SERVICE INFORMATION BULLETIN

NUMBER: 15-271-20

SUBJECT: Discontinuation of “Stitcher” App and News Radio Feature
 from STARLINK App: Gen 2.0, 2.1, (Fujitsu / Denso TEN)
 and Gen 3.0, 3.1 (Harman) Audio Systems

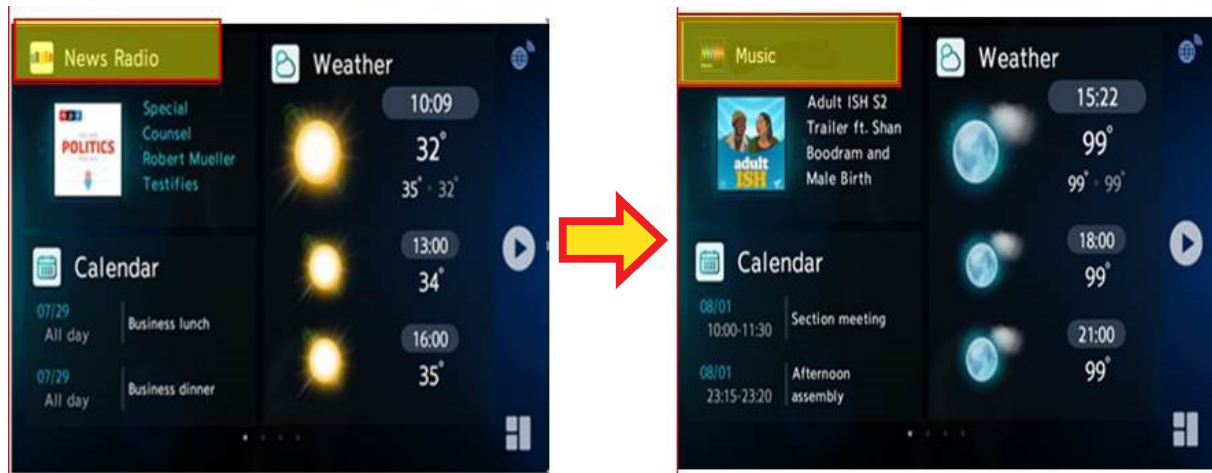
This Service Information Bulletin announces discontinuation of both the “Stitcher” app and the related News Radio feature from the STARLINK app lineup effective 12:00 midnight on Thursday, September 24, 2020. This change effects Denso TEN (a.k.a. Fujitsu TEN) Generation 2.0 and 2.1 along with Harman Generation 3.0 and 3.1 infotainment / audio systems. Users will likely receive notification on their display as shown below.

With the departure of Stitcher, there will no longer be support for the Application Programming Interface (API) software which allowed the Stitcher and News Radio applications to communicate with each other. As a result, the **News Radio** feature will be replaced by “**Music**” as shown in the screen shots below. The News Radio icon will also disappear.
